Our Ref: R/2024/5
File No: 2024/356221
Your Ref: SSD-49320959

SSD-49320959 – Environmental Impact Statement – Rosebery Seniors Living

The proposed development involves the construction of a seniors living housing development across six buildings including 170 independent living units and a 34-bed residential care facility at 22-40 Rosebery Avenue and 108 Dalmeny Avenue, Rosebery. The development also involves the delivery of community infrastructure including the dedication of land across the southern side of the site in the form of 8m wide laneway and a creation of a 4m wide through site link (easement) across the northern side of the site.

Figure 1: Section through southern land dedication

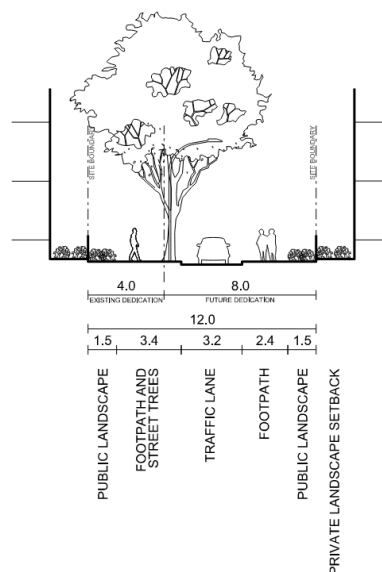
The architectural plans identify the southern land dedication as a 'Pedestrian/Cycleway'. The plans are to be amended reflect the intended road design which includes a single vehicle lane (east to west) as required by Section 5.7.1.1 of the Sydney Development Control Plan 2012 ('SDCP 2012').

The proposed design includes trees within the footpath along the northern side of the traffic lane. These trees are to be relocated to the southern side of the vehicle lane within the garden bed in accordance with Figure 1 above so that a continuous footpath can be provided along the northern side of the traffic lane. This may require some works on council land within the existing dedicated land portion, however, may be facilitated as part of the VPA as integration works.

Figure 2: Extract from SLEP 2012 Height of buildings map

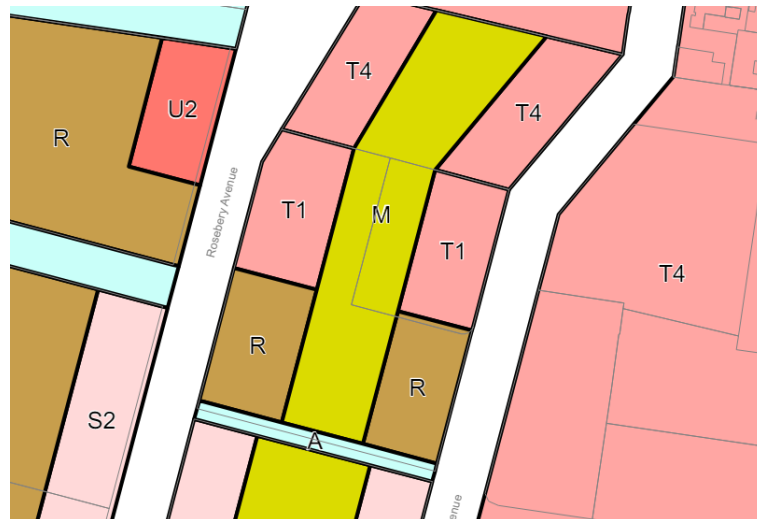
The site is subject to varying height of building development standards as shown in Figure 2 below. The 3.8m additional height is also calculated in Table 1 further below.

The proposed development does not comply with subsection 87(2)(c) and is accompanied by a written request to vary the development standard pursuant to Clause 4.6 in SLEP 2012.

The proposed height variations occur for buildings A, B and C and range from 0.4m (1.3%) to 2.5m (9.68%).

Figure 3. Typical ground floor condition for residential development (Section 5 of the DCP)

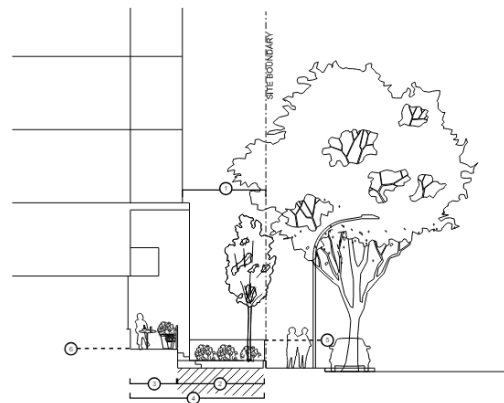
The proposed building would not comply with the ground floor level and first level setbacks as ordinarily required by Section 5.7.2.1 of SDCP 2012. The diagram in Figure 3 below, taken from Part 5 of SDCP 2012 should be utilised as a guide. These setbacks should be applied consistently as done so throughout the North Rosebery Precinct.

The provision of a ground floor level setback would also assist to facilitate the provision of direct entries to the ground floor level apartments. Providing individual ground level entries would improve the amenity of these apartments and improve the connection to the street.
